49 CFR Part 571

Federal Motor Vehicle Safety Standards; Seat Belt Assembly Anchorages, School Bus Passenger Seating and Crash Protection

ACTION: Final rule; response to petitions for reconsideration.

Figure 5 – Minimum school bus torso belt adjusted height measurement

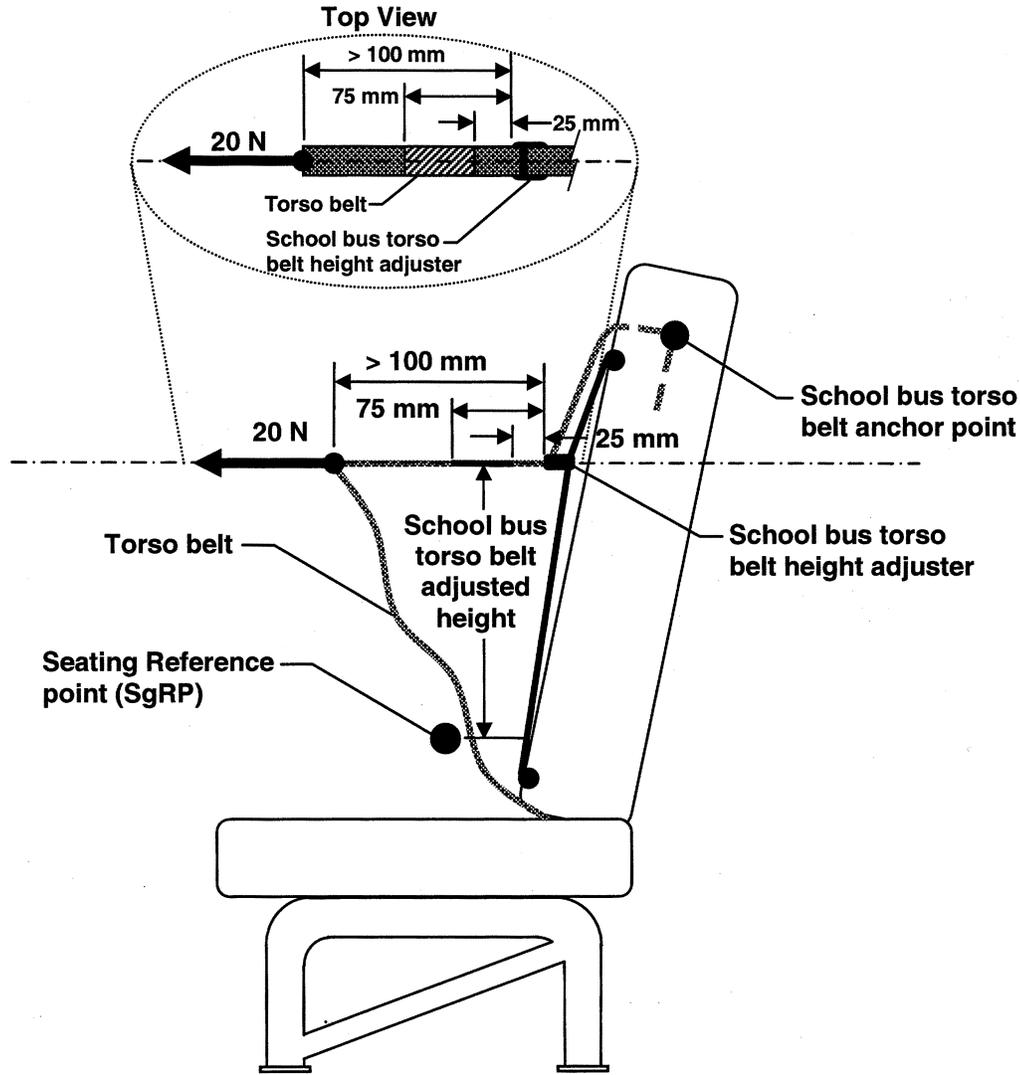
Petition for Reconsideration—In its petition for reconsideration, Blue Bird asked NHTSA to clarify the definition of "school bus torso belt adjusted height," particularly with respect to the phrase "deviates more than 10 degrees from the horizontal plane." Blue Bird stated that it is not possible to pull the webbing in a horizontal plane and maintain the original point of belt contact because the arc of the belt forces load the application device downward since the lower anchor point is fixed.

NHTSA's Response—The request is granted. We are clarifying the definition of "school bus torso belt adjusted height" and adding a new Figure 5 in FMVSS No. 210 to set forth in a clearer, more detailed manner how the torso belt adjusted height measurement will be made. The revised definition removes the confusing phrase "deviates more than 10 degrees from the horizontal plane" and adds a new figure to indicate that the measurement is made to a horizontal segment of the torso belt that is located between 25 mm to 75 mm (1 in to 3 in) forward of the adjustment device while applying a horizontal 20 N

(4.5 lb) force to the belt in the forward direction. The 20 N (4.5 lb) horizontal force is applied in the forward direction through the webbing at a location greater than 100 mm (3.94 in) forward of the adjustment device (as shown in the new Figure 5) after the retractor has been locked. Figure 5 also illustrates that slack should remain in the portion of the belt between its bottom anchorage and the point of force application. This slack allows the upper portion of the torso belt, between the point of force application and the adjuster, to be pulled in a horizontal plane. We believe these amendments address the petitioner's concerns.

School bus torso belt adjusted height means the vertical height above the seating reference point (SgRP) of the horizontal plane containing a segment of the torso belt centerline located 25 mm to 75 mm forward of the torso belt height adjuster device, when the torso

belt retractor is locked and the torso belt is pulled away from the seat back by applying a 20 N horizontal force in the forward direction through the webbing at a location 100 mm or more forward of the adjustment device as shown in Figure 5.
